TOWN OF COVENTRY, RI
DEPARTMENT OF PLANNING & DEVELOPMENT

STAFF REPORT

Project Name:	Gormley Garage/ADU
Plan Type:	Unified Development Review (Accessory Dwelling Unit w/ associated Dimensional Variance)
Owner/Applicant:	Gregory Gormley
Address:	33 Brian Hollow Road
Plat / Lot / Zone:	AP 323 Lot 120 Zone RR-3 Lot Size 1.66
Existing Use:	Single-Family Dwelling
Proposed Use:	Single-Family Dwelling with an Accessory Dwelling Unit (ADU) and Garage
Description:	The applicant proposes to construct a 1,288 SF, 28' x 46' one-bedroom Accessory Dwelling Unit (ADU) as a second floor above a proposed new garage on their 1.66-acre subject parcel. Applicant seeks three dimensional variances as the ADU and garage will be placed in the front yard, will be sited within the minimum side setback, and will exceed the maximum allowable floor area requirements.

TECHNICAL REVIEW COMMITTEE REPORT

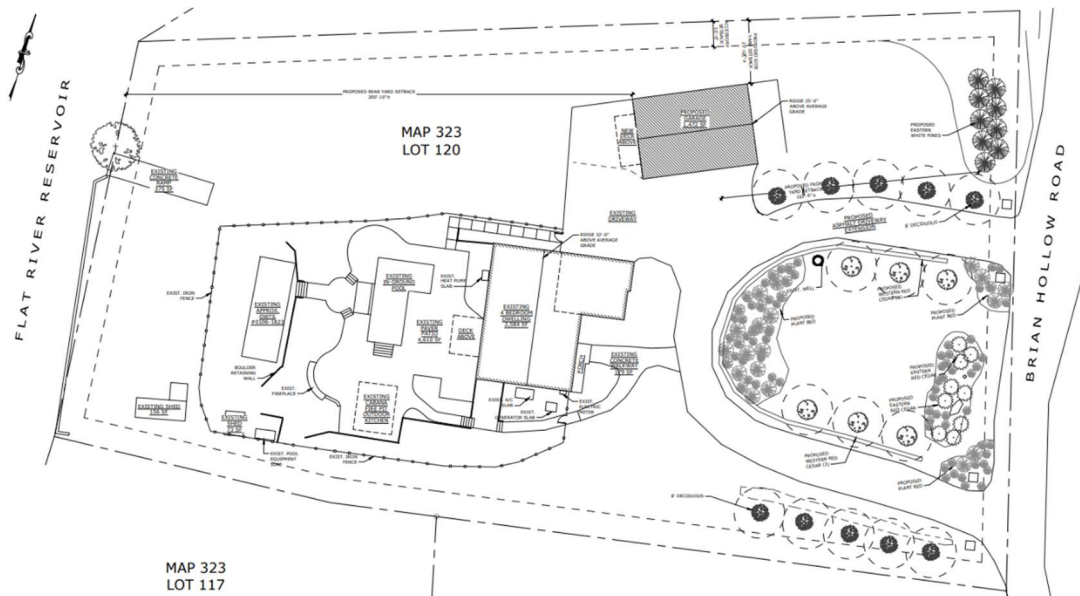
The applicant's revised site plans, submitted on December 9, 2025 (shown below), includes a landscape plan to ensure reasonable screening of views from the abutting neighbors and the public right-of-way. The proposed plantings include the following mix of vegetative types: (1) eastern white pines to the north of the driveway entrance along the property's frontage on Brian Hollow Road, (2) deciduous trees along the driveway leading to the applicant's house, (3) a combination of western red cedar, eastern red cedar, (4) smaller planting beds to the south of the driveway entrance along the parcel's frontage, and (5) deciduous trees along the property's southeastern edge.

- Staff added the following considerations: The revised site plans include proposed tree plantings and plant beds along the parcel's frontage on Brian Hollow Road and the driveway entrance into the house to provide reasonable screening from abutting neighbors and the public right-of-way. In addition, the proposed accessory structure will appear incidental and subordinate to the principal structure, as the three garage doors will make the entire structure resemble a customary garage, as opposed to an additional housing unit.
